UNITED STATES PATENT AND TRADEMARK OFFICE

10/523,024

Arcangelo Manfrotto

Office Action Summary

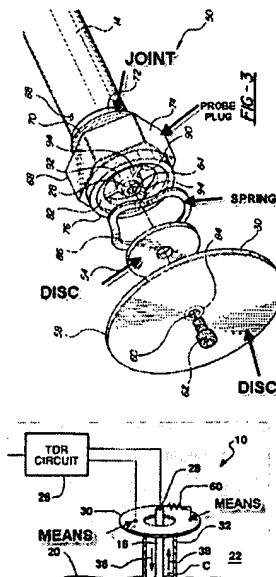
As shown in the drawing on the top-left, Innes teaches a probe plug (74) in column 5, lines 20-25; it teaches a joint (70) in column 5, lines 14-17; it teaches a disc element (30) for an electric contact in column 4, lines 13-14; it teaches a spring (86) in column 5, lines 41-47. As shown in the drawing on the bottom-left, Innes teaches means for supplying probe and/or transmitting an electric signal to a circuit board.

Thus, Innes reasonably appears to teach and disclose every element of claim 1 and therefore anticipates this claim.
